City of Portland, Maine - Building or Use Permit Application 389 Congress Street, 04101, Tel: (207) 874-8703, FAX: 874-8716

BUILDING PERMIT REPORT
DAT	TE: 25 Sept. 99 ADDRESS: <u>B3 Exchange ST</u> . CBL: <u>B32-E-999</u>
REA	SONFORPERMIT: InTerior Tenant F.T up.
	LDING OWNER: B: G. LimiTed
PER	MIT APPLICANT: 1/Contractor STerm Co.
USE	$\operatorname{group}_{\mathcal{M}} \operatorname{construction} \operatorname{type}_{3\mathcal{B}}$
	City's Adopted Building Code (The BOCA National Building Code/1996 with City Amendments) City's Adopted Mechanical Code (The BOCA National Mechanical Code/1993)
	CONDITION(S) OF APPROVAL
This	permit is being issued with the understanding that the following conditions are met: $\frac{1}{2}$, \frac
Appr	oved'with the following conditions:
₹ <u>1.</u> 2.	This permit does not excuse the applicant from meeting applicable State and Federal rules and laws. Before concrete for foundation is placed, approvals from the Development Review Coordinator and Inspection Services must be obtained.
	(A 24 hour notice is required prior to inspection)" <u>ALL</u> LOT LINES SHALL BE CLEARLY MARKED

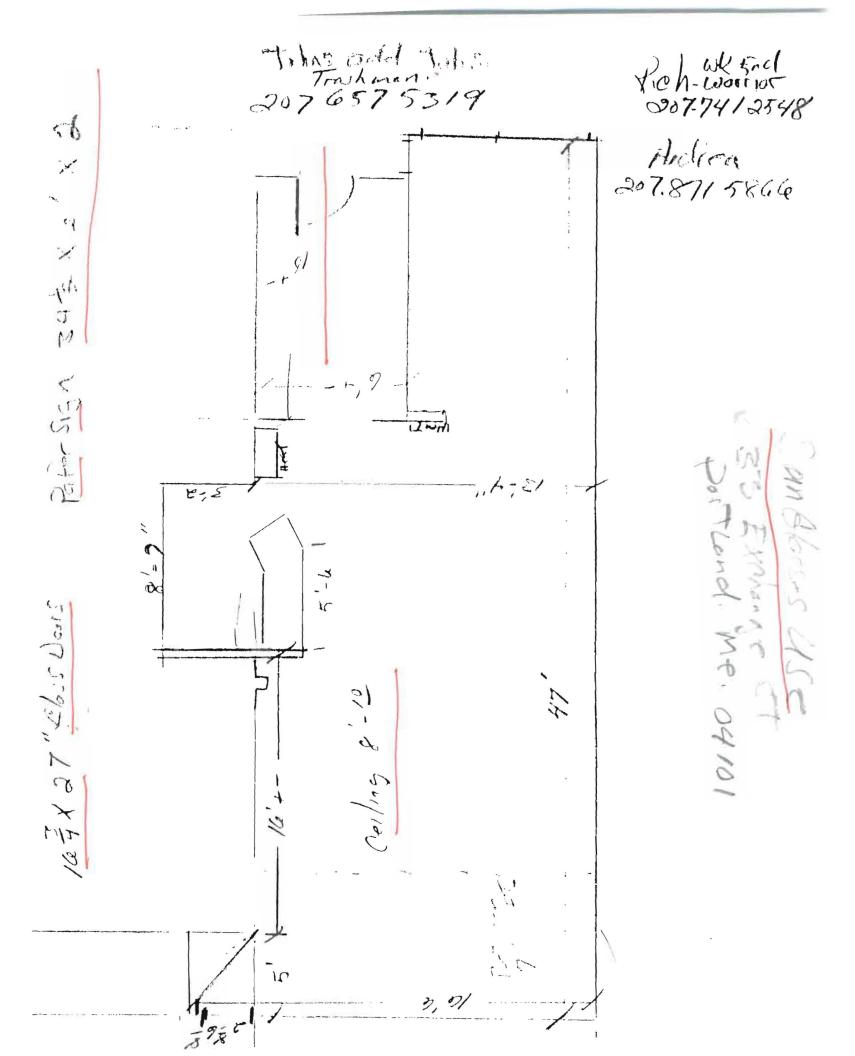
1990).
X35.	Section 1006.2.4.1 Egres ; A mirror Shall Not be placed so a
	To give The appearance of a doorway, exit or passageway.
36.	
37.	·
20	
38.	
$\langle \rangle$	A ATA
10	A second of the second s
Sam	ter Hoffses, Building/Inspector
cc:	Lt. McDougail, RED
	Marge Schmuckal, Zoning Administrator
	H. Y. M. J
DCU 7/7+00
